ATTACHMENT D1

**Uranium One ISR Wellfield Hydrologic Impact Analysis
(Response to RAI 56)**

RAI 56

POTENTIAL IMPACTS FROM IRRIGATION WELL SMITH #1

**MAXIMUM DRAWDOWN AND RADIUS OF INFLUENCE
 OF SMITH #1 IRRIGATION WELL, O-SAND AQUIFER**
 SMITH RANCH-HIGHLAND/REYNOLDS RANCH FACILITIES
 CONVERSE COUNTY - WYOMING

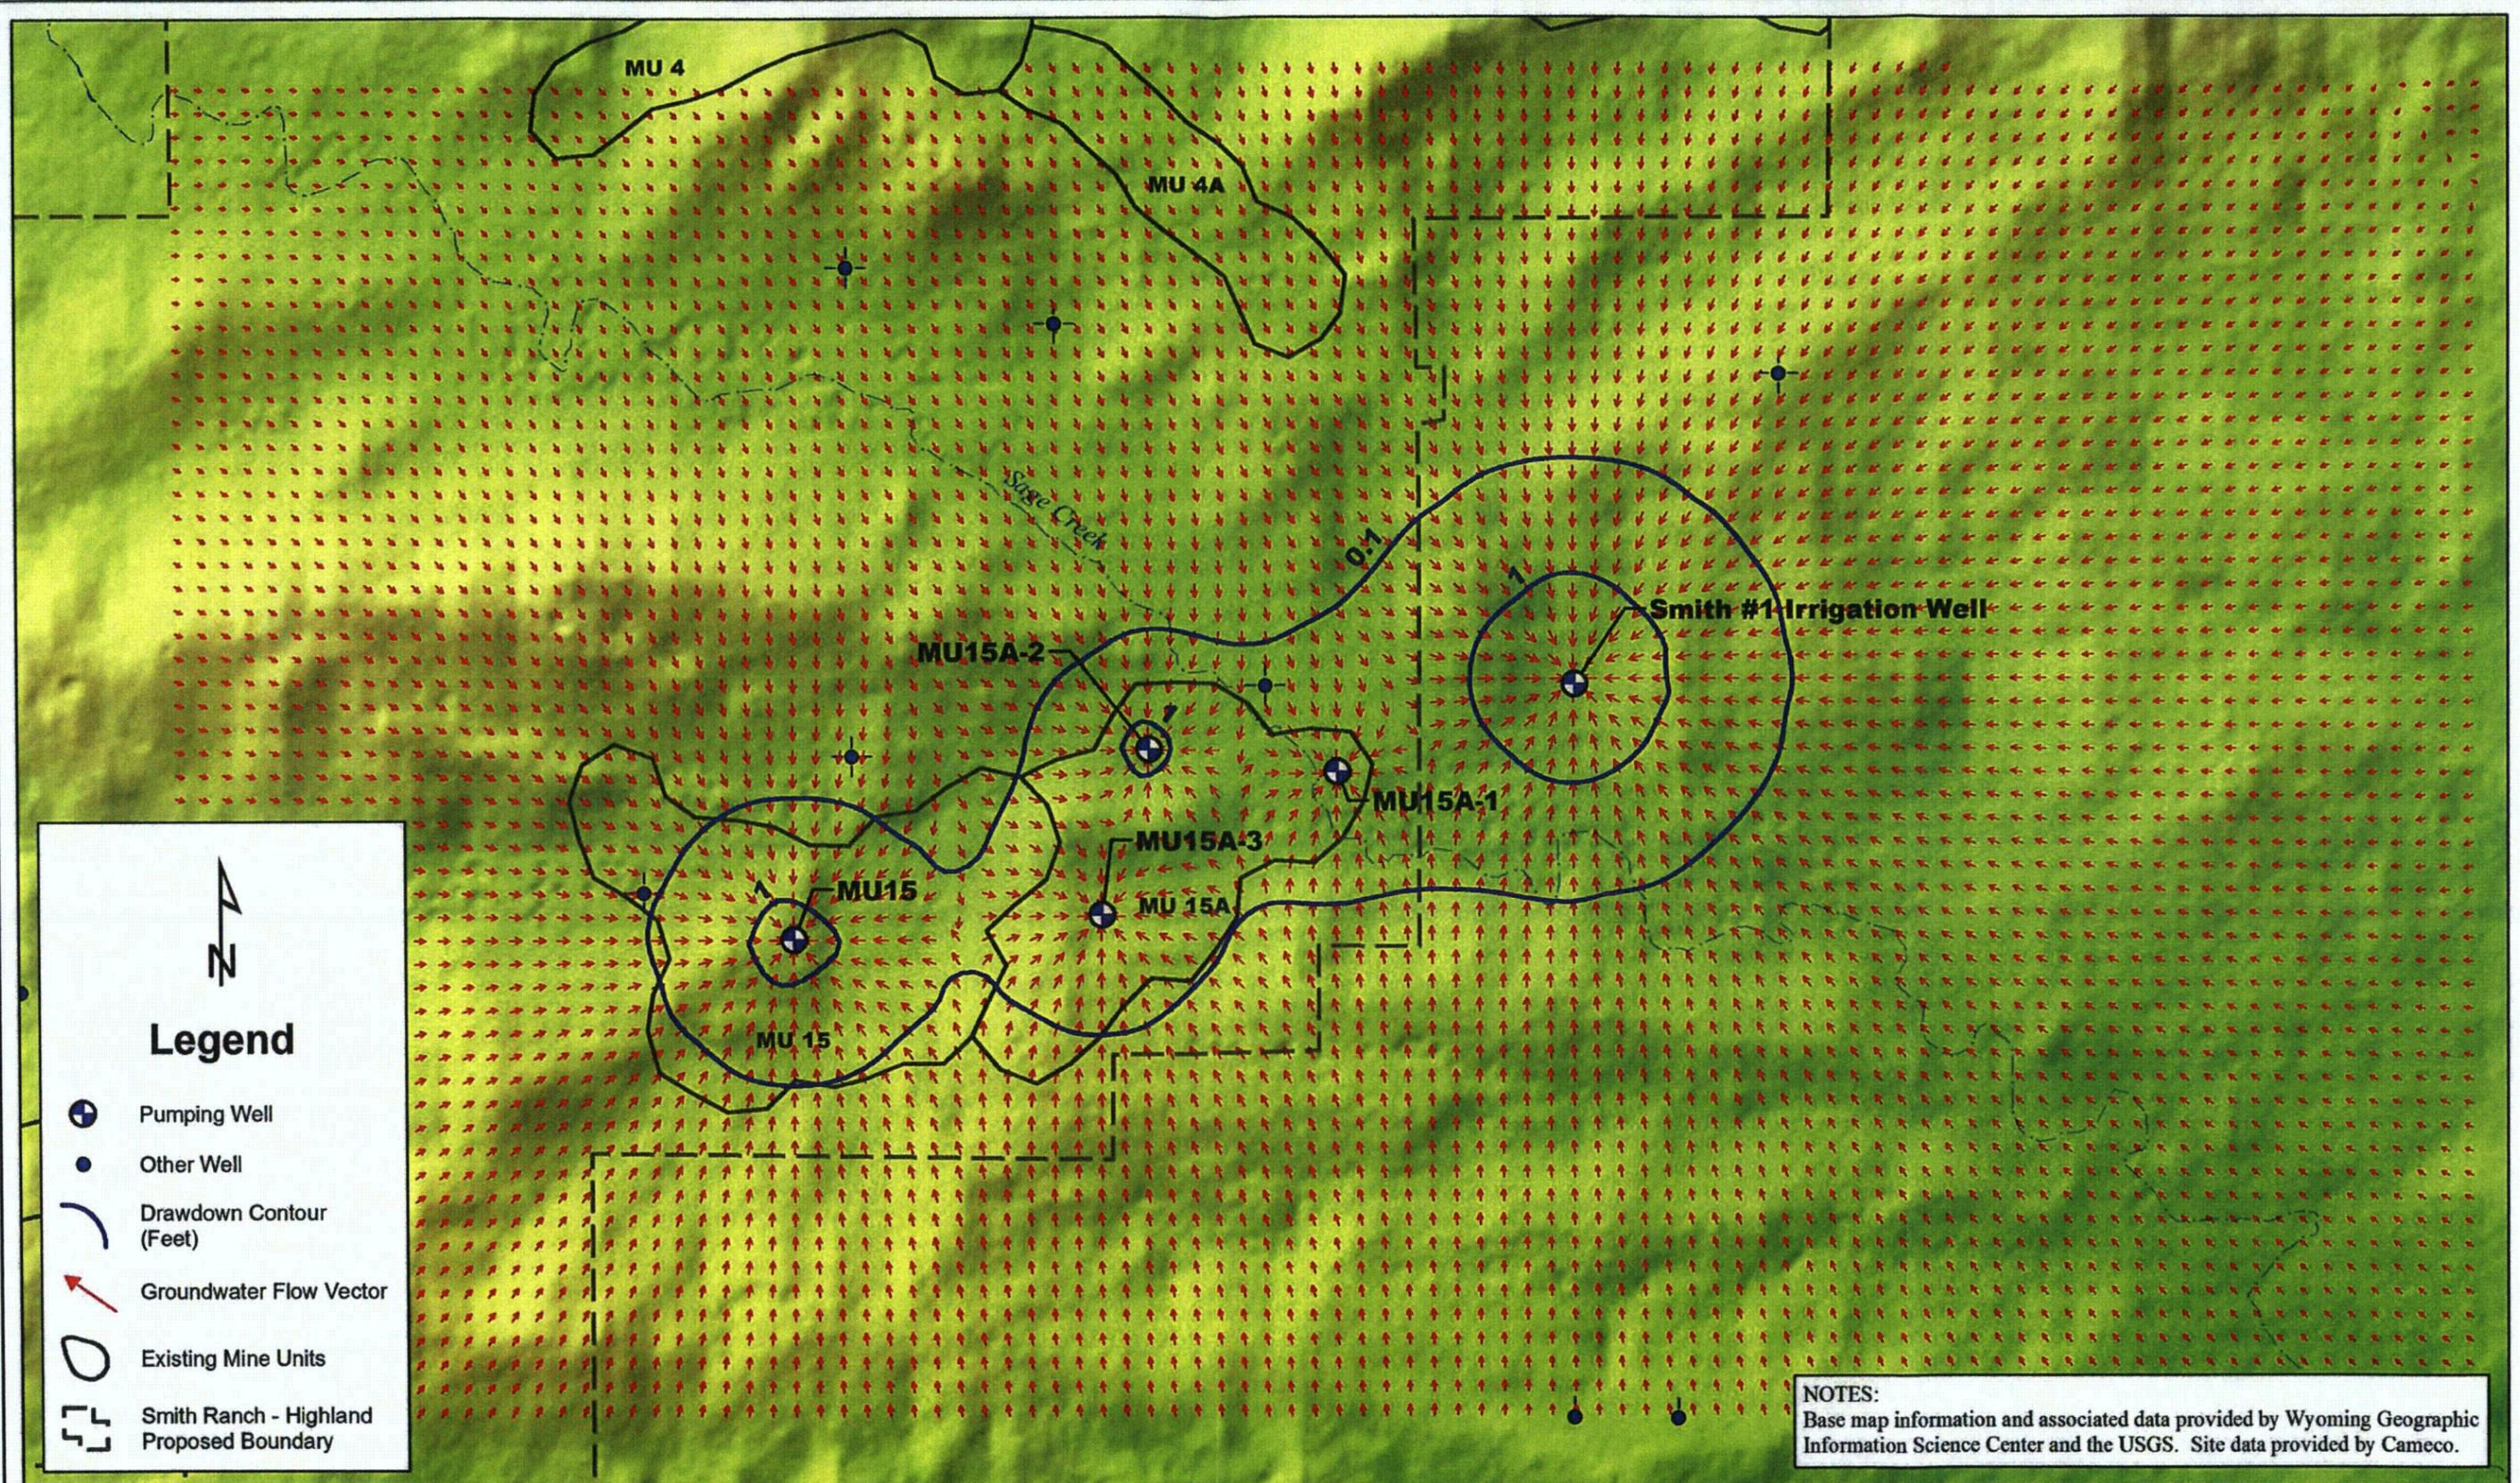
"Cameco stated two irrigation wells were completed in Section 12 of T35N, R74 W on page D6-12 of the Wyoming Department of Environmental Quality (WDEQ) Smith Ranch permit. Staff was not able to find the Wyoming State Engineer's Office (WSEO) permit numbers for these wells to determine their completion interval or ground water rates to assess if they may affect the safety of operations.

Please provide the WSEO permit names for the two irrigation wells installed in Section 12 of T35NR74 W. Please identify the aquifers in which these wells are completed. Please provide the current status of these wells. Please assess if the ground water use at these wells could affect hydraulic control of nearby mine units within the Smith Ranch license area".

A single permitted irrigation well is located within Section 12 of T35N, R74W. The permit number is P2414W (Smith #1). WSEO records indicate that this well has a total depth of 600 feet, a static water level of 154 feet, and has a permitted maximum flow rate of 100 gpm. The well is perforated from 218-230, 350-400, 402-420, and 450-555 feet below ground surface. The lower perforated zones are located in the O-Sand within the Fort Union Aquifer System. This well is located approximately 3,200 feet east of the closest injection and production wells (P196924W) in Mine Unit 15A (T25N, R74E, Sec 11, SENE). The injection and production wells are also perforated in the O-Sand.

The resulting maximum drawdown and radius of influence produced by irrigation well Smith #1 after 5 months of irrigation is shown on **Figure 1**. These results demonstrate irrigation pumping from Smith #1 should not adversely affect hydraulic control of mining solutions in neighboring mine units, as the drawdown and resulting radius of influence produced by irrigation pumping is insufficient to overcome the inward hydraulic gradient produced by the production bleed in MU-15A.
